ENGINEERING CHANGE NOTICE

1. ECN 655974  
Proj. ECN

13a. Description of Change  
 Changes to capture facility AS-BUILT configuration; including change to two (2) operating bays. Also includes general editorial changes from Rev. 0.

# **Cold Vacuum Drying Facility Crane and Hoist System Design Description System 14**

FIGURE 3-1  
THE LAYOUT OF  
HOIST AND CRANE SYSTEM  
CONTROL BOX

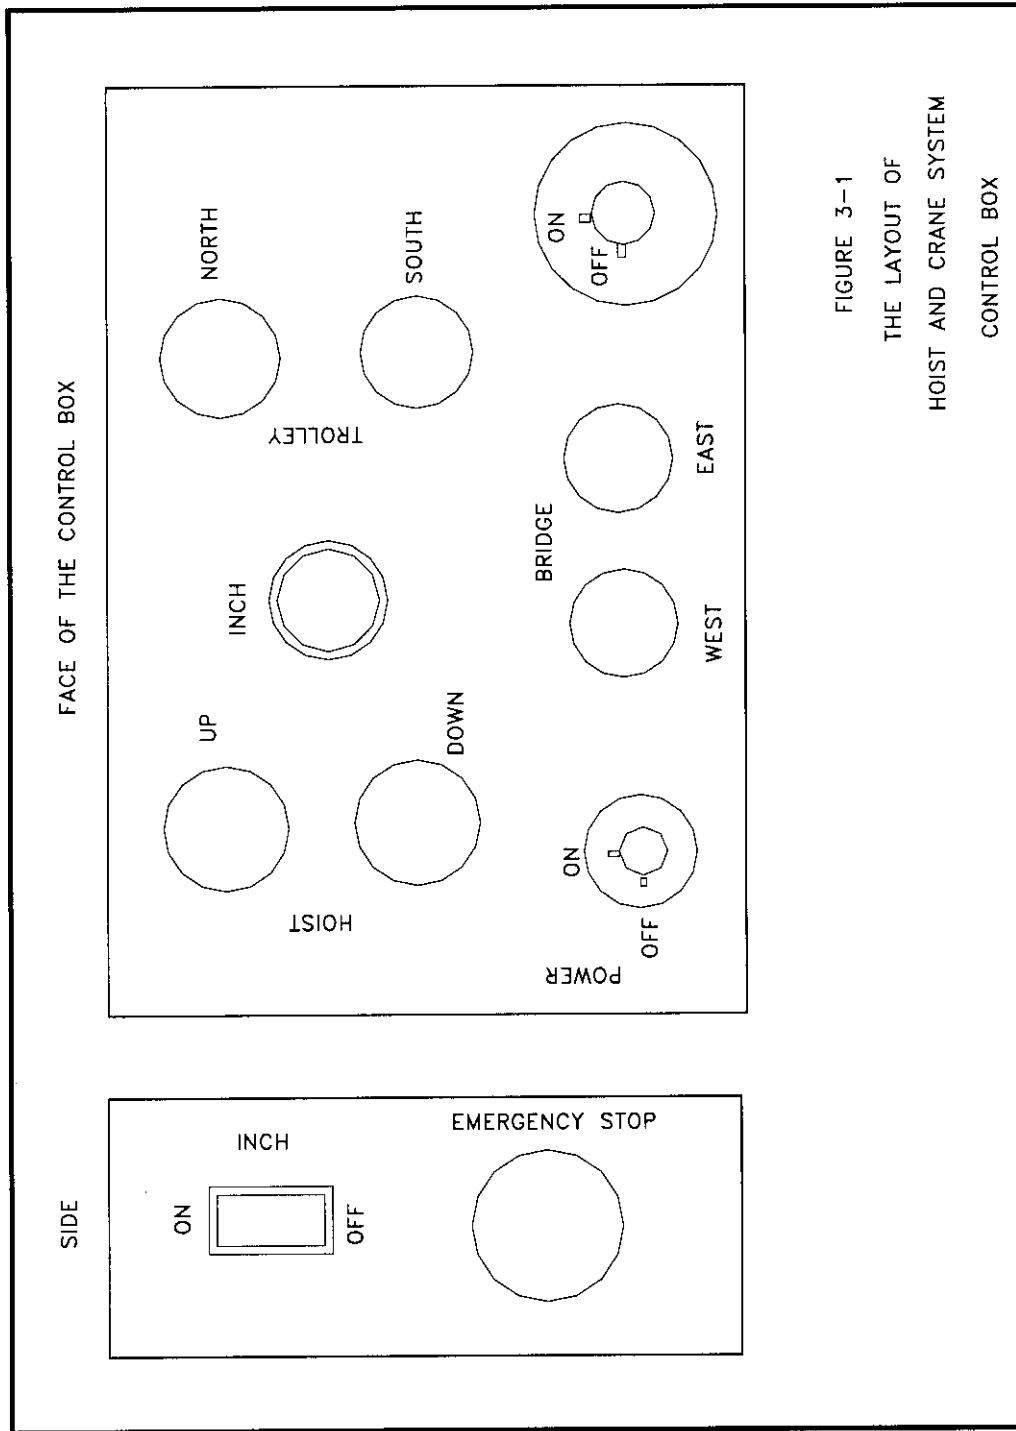
- **Pushbutton Stations:** The station is a box that is mounted to the mezzanine guardrail in each active process bay and is powered by 120 volts AC. The layout of the control box is shown in Figure 3-1. The box consists of the following:
